SAND80-1323
Unlimited Release
October 1980

STRATEGIC PETROLEUM RESERVE (SPR)
GEOLOGICAL SUMMARY REPORT
WEEKS ISLAND SALT DOME

T. S. Ortiz
SPR Geotechnical Division 4543
Sandia National Laboratories
Albuquerque, **NM** 87185

Figure 6 - MINE PLAN RELATIVE TO SALT DOME (From Acres American, Inc., 1979, Strategic Petroleum Reserve, Weeks Island Mine - Additional Geotechnical Studies, Subcontract No. 1-SC-5822-4013 to the Ralph M. Parsons Co. for U. S. Department Of Energy - Parsons-Gilbane)

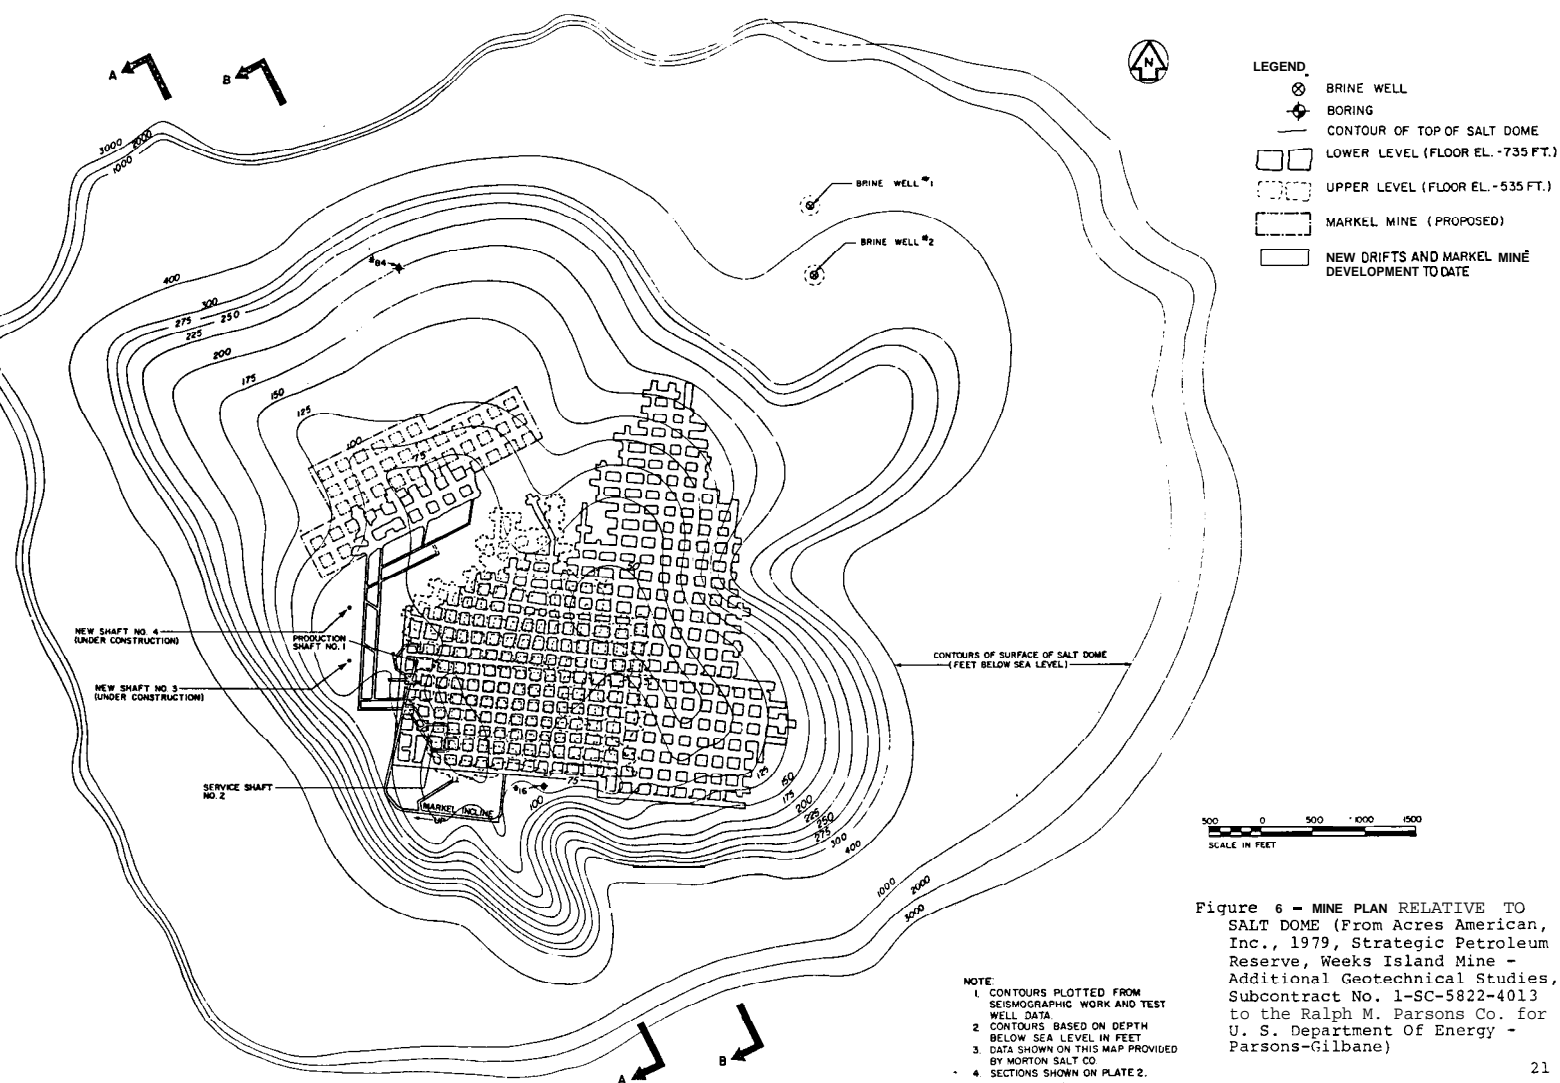
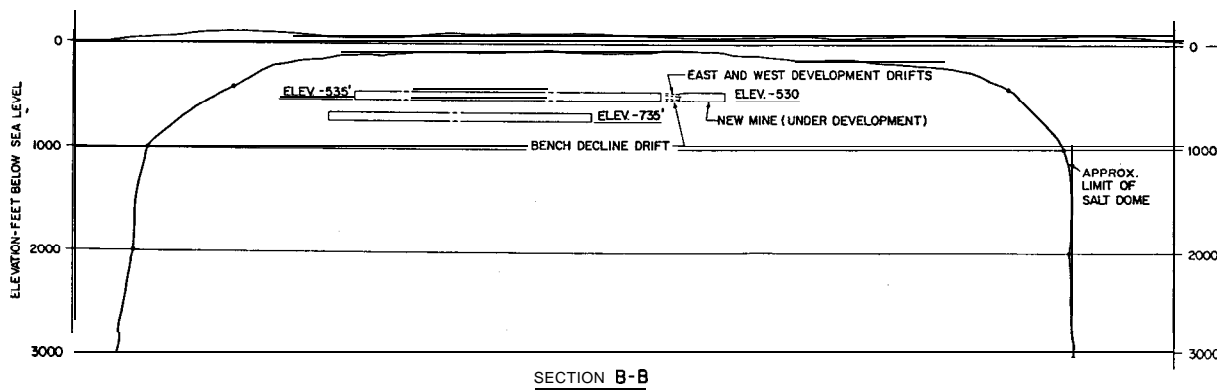
3. That sonar logging be performed in brine wells No. 1 and 2 (Fig. 6) to determine the actual configuration of the solutioned caverns. Depending on the results of sonar logging, solution mining may have to be curtailed or controlled to ensure the safety of the oil repositories.

- (4) The utility of the information obtained from pressure tap readings is uncertain.
5. That an attempt be made to locate and, if required, seal boring No. 16 located approximately 100 feet south of the mine (Fig. 6).

- (3) Brine well 2, 1400' from the oil storage area was sonar surveyed in May 1978. The well is about 100-150' in diameter from -325' to -1510'. Brine well 1, farther from the mine than well 2 has not been sonar surveyed. Sandia does not feel that it is imperative to sonar survey well 1 at this time. However, if Morton Salt Company does sonar survey either well at any time, Sandia recommends that DOE request copies of the survey.

- (5) Sandia agrees.
6. That an attempt be made to locate and seal the 5 known borings (Fig. 9) and any other borings made in the floor of the lower level and that large pillars (of the order of 400-foot diameter) be left in any new level mine around those holes that 'cannot be adequately sealed to ensure no leakage of oil into the new level.'
